DESIGN REVIEW STAFF REPORT – SINGLE FAMILY

2427 Hollister Terrace

PADR-000985-2023

The project proposes a 510 square-foot addition at the rear of an existing two-story, 2,925 square-foot single-family dwelling (built in 1931) with a detached 492 square-foot garage located on a 7,340 square-foot lot. The proposed addition will be on the second-story, replacing an existing attic space and contained within the existing envelope of the house. The front façade will also be remodeled to repair the existing balcony, and no style changes will be made.

a4.1

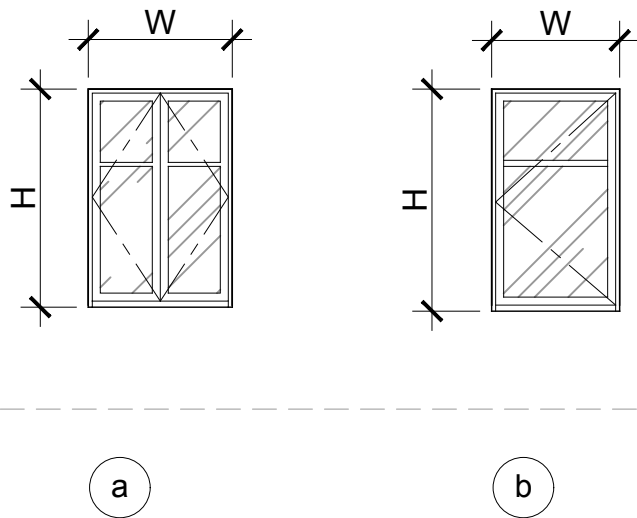
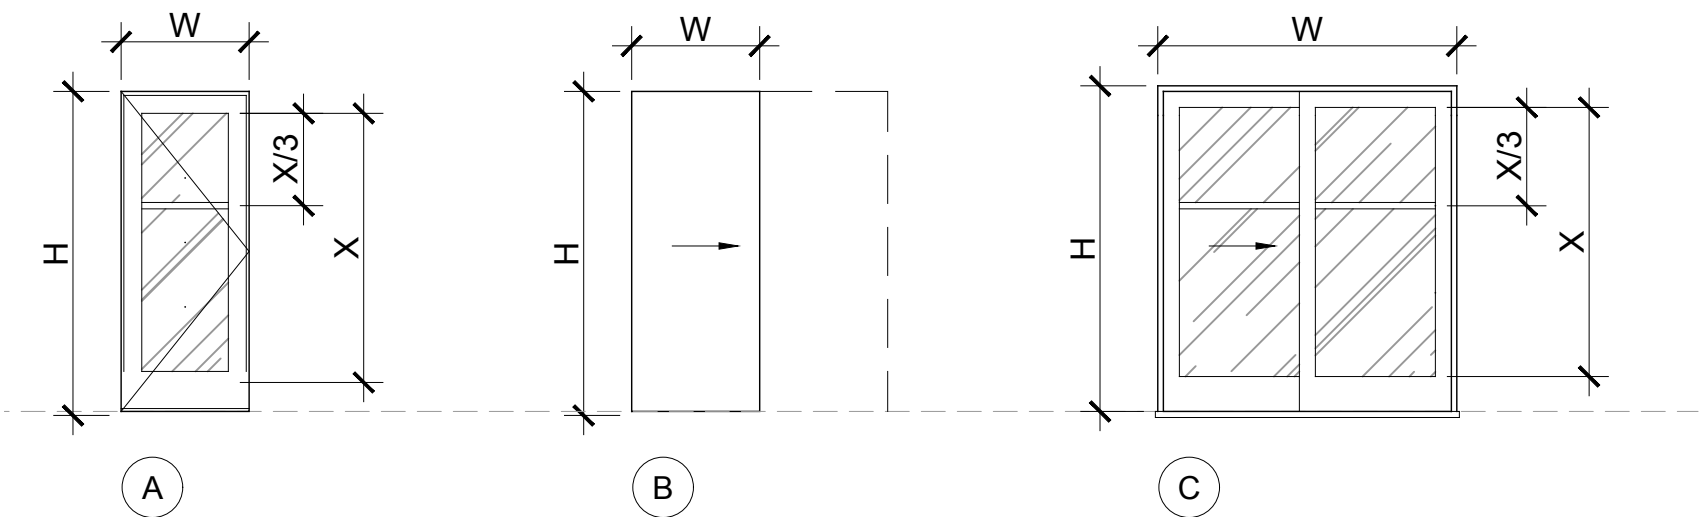
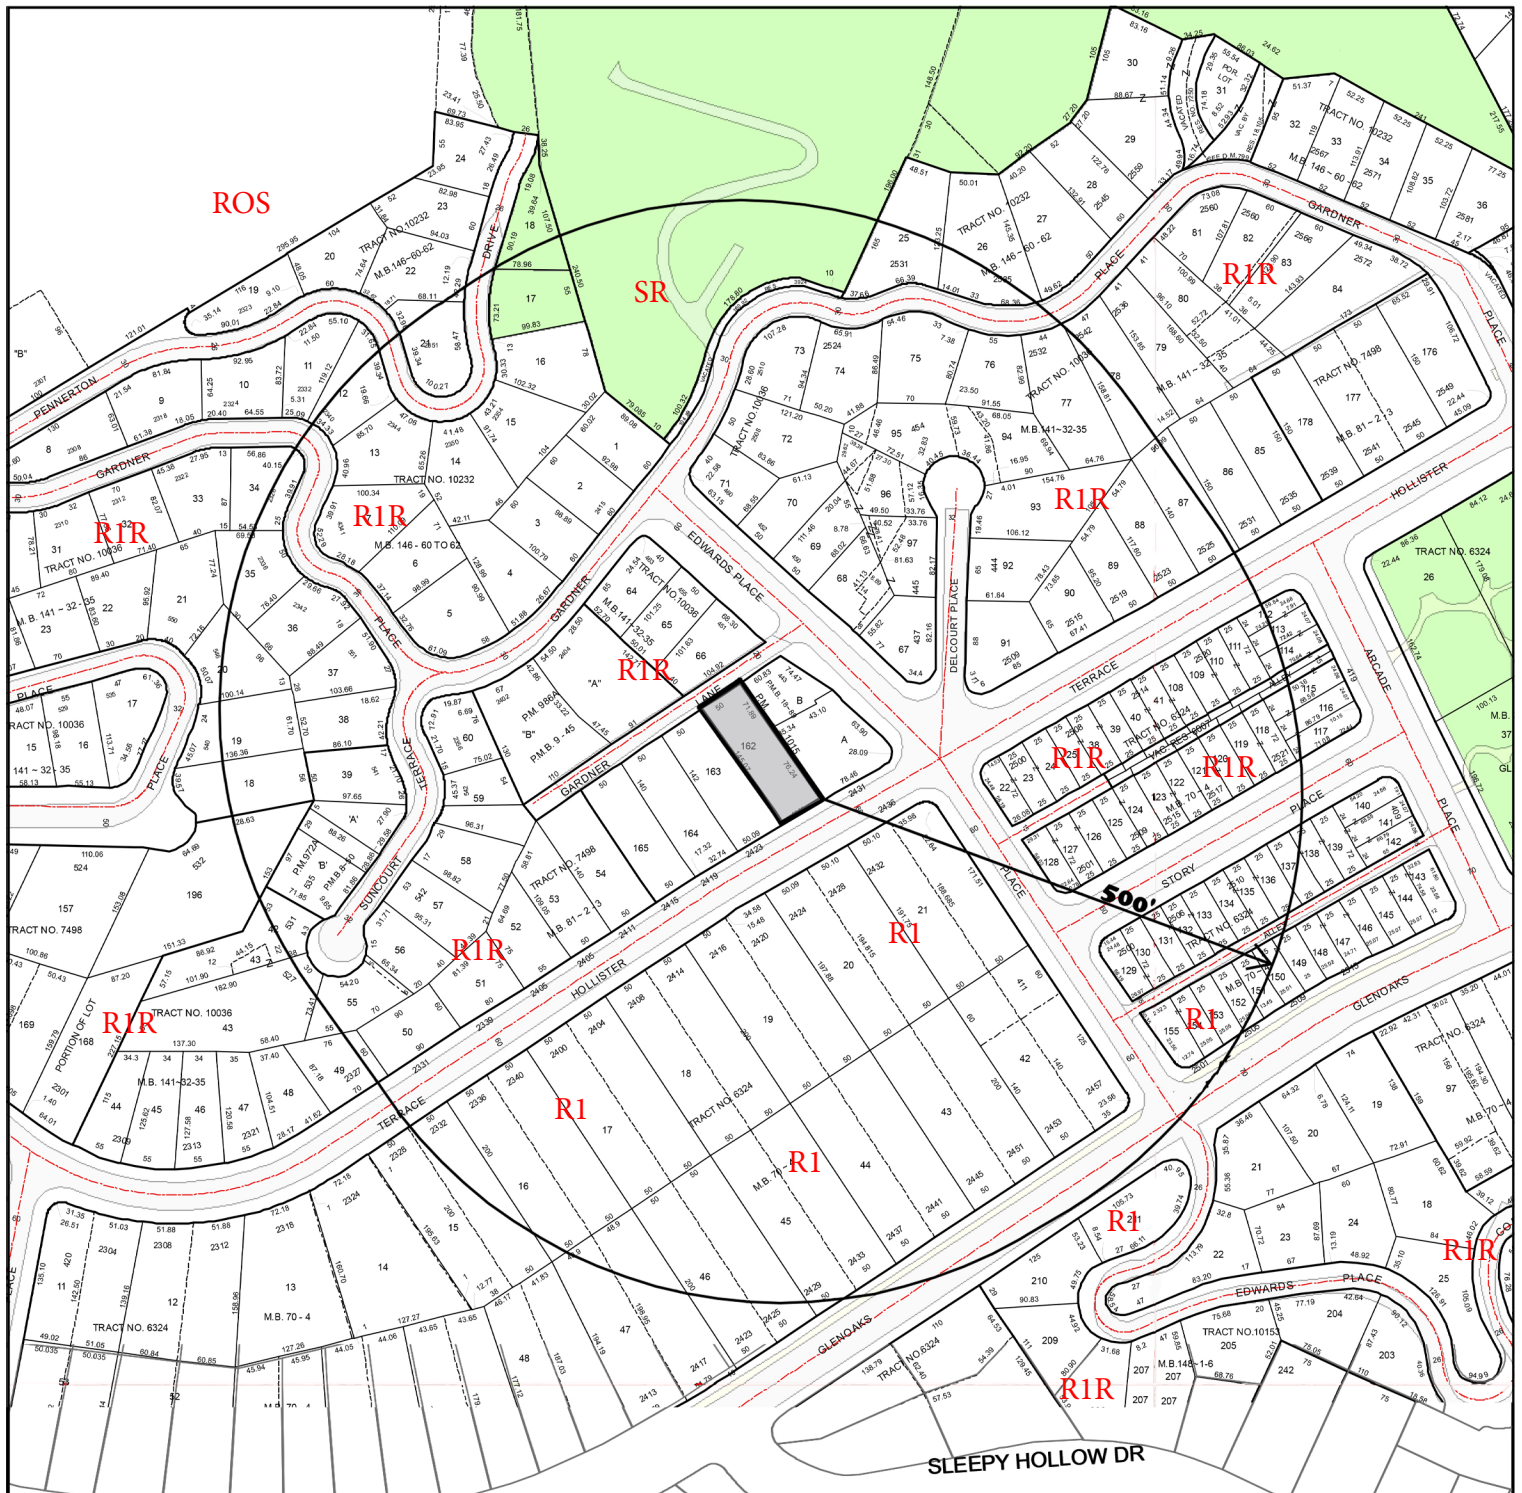
- The finish materials are appropriate to the style including stucco finish, wood-clad windows and terracotta attic vents.
 - The new windows for the addition are wood-clad and feature casement operations. The new windows will match the pattern of the existing windows, including the wood mullions. A condition is included to revise the window schedule to show complete details of frame type and provide a window section drawing.

1. That the window schedule be revised to show frame type and window sections.
 2. That specifications (cut sheets) for the exterior lighting fixtures on the new building and locations shall be submitted for staff review and approval prior to plan check submittal. The exterior lighting should be appropriate to and consistent with the style of the addition and their locations should be limited to the main entry and patio doors.
 3. That the gutters shall be painted to match the adjacent wall color.
-
